**JOINT REGIONAL PLANNING PANEL  
(Sydney East Region)**

<b>JRPP No</b>	<b>2014SYE084</b>
<b>DA Number</b>	<b>LDA 2014/236</b>
<b>Local Government Area</b>	<b>City of Ryde</b>
<b>Proposed Development</b>	<p>The proposal seeks consent for the demolition of the existing factory buildings and associated structures and construction of a mixed use development containing two x six storey buildings comprising of a commercial component and sixty two (62) apartments:</p> <ul style="list-style-type: none"> <li>• Building A facing Porter Street will have a retail component of 122m<sup>2</sup> on the ground floor and will contain 28 apartments.</li> <li>• Building B facing Church Street will have a retail component of 88m<sup>2</sup> on the ground floor and will contain 34 apartments.</li> <li>• The development proposes 91 carparking spaces over two half levels and one full level of basement carparking with all vehicular access from Porter Street.</li> </ul>
<b>Street Address</b>	13-15 Porter Street and 115-117 Church Street, Ryde

## **Assessment Report and Recommendation**

Figure 4: Location of the retail premises – on the ground floor of each of the buildings, with the retail facing each of the respective streets and facing Hayes Reserve.

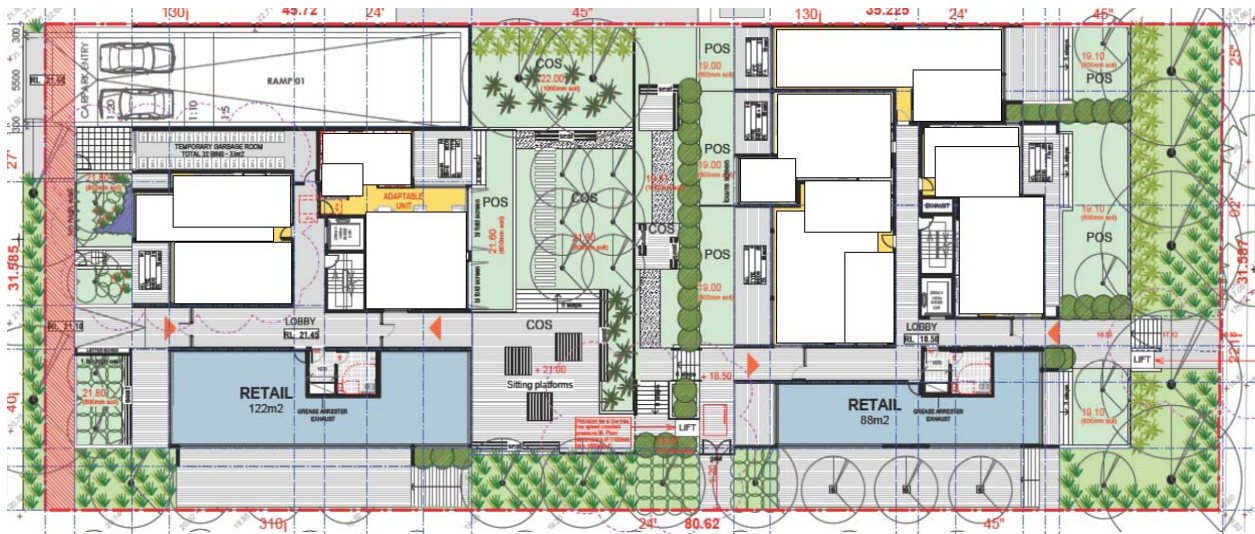
*The location of this site along Hayes Reserve and the associated pedestrian link is a desirable retail/commercial tenancy location within the local context. However the viability of small retail/commercial tenancies along Church Street is questioned. The Panel recommends locating retail tenancies at ground floor of each building along Hayes Reserve. Home office uses, if desired, could be relocated to Porter Street. SOHO units should be designed with a true commercial space facing the street and attached to a residential unit on the floor above. The space could be used for residential or commercial depending on the market and would provide opportunities for a greater mix of uses.*

A retail/commercial component is provided on the ground floor of each of the building with the retail facing each of the respective streets (Porter and Church Streets) and facing Hayes Reserve. A usable outdoor area is proposed adjacent to the retail and

Hayes Reserve which will activate this frontage and provide passive surveillance to the reserve.

Figure 5: The Communal Open Space located between the two buildings, with access from both buildings.

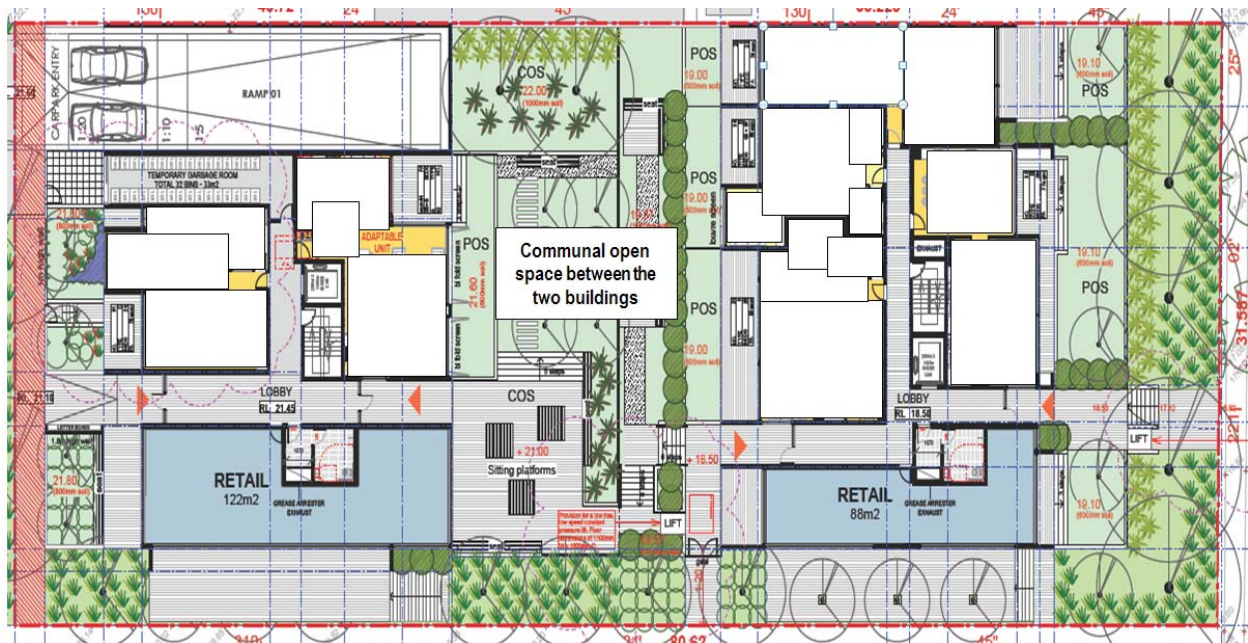
*Greater detail is needed on the resolution of the central courtyard and its levels. The courtyard is a great asset for the residents and has the potential to link to Hayes Reserve.*

The central courtyard is well designed with seating platforms and access to Hayes Reserve however due to the topography across the two allotments, the communal area is not all one level. The communal space steps down towards Church Street

however disabled access has been provided across the site, linking access from Porter Street to Church Street.

Figure 6: Cross Section of Buildings A & B height variation from 9.5m and new height control 21.5m.

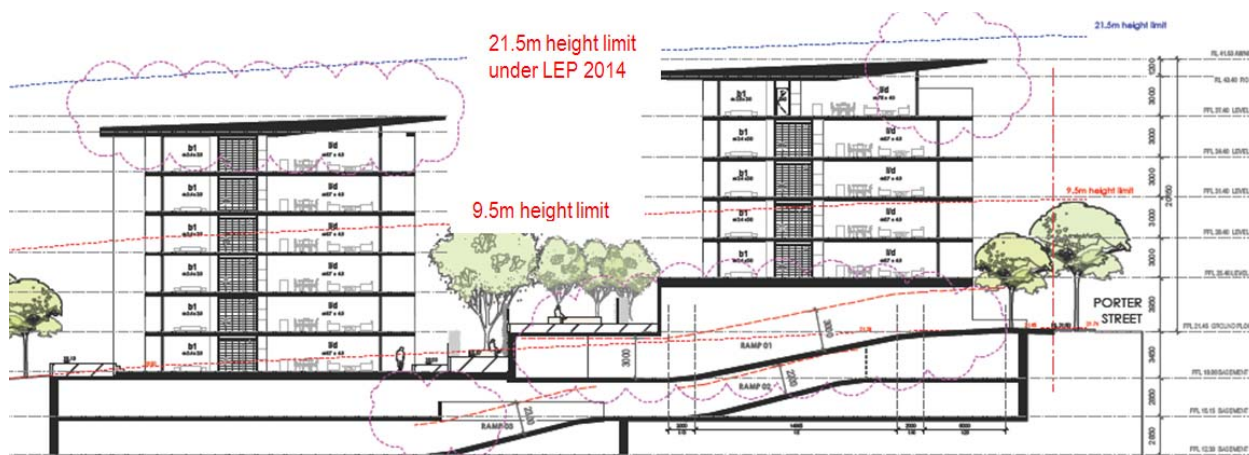
Nevertheless, under RLEP 2014 the maximum height of buildings permitted on the site is 21.5m and if the application was submitted after 12 September 2014, the development would comply with the maximum height of RLEP 2014.
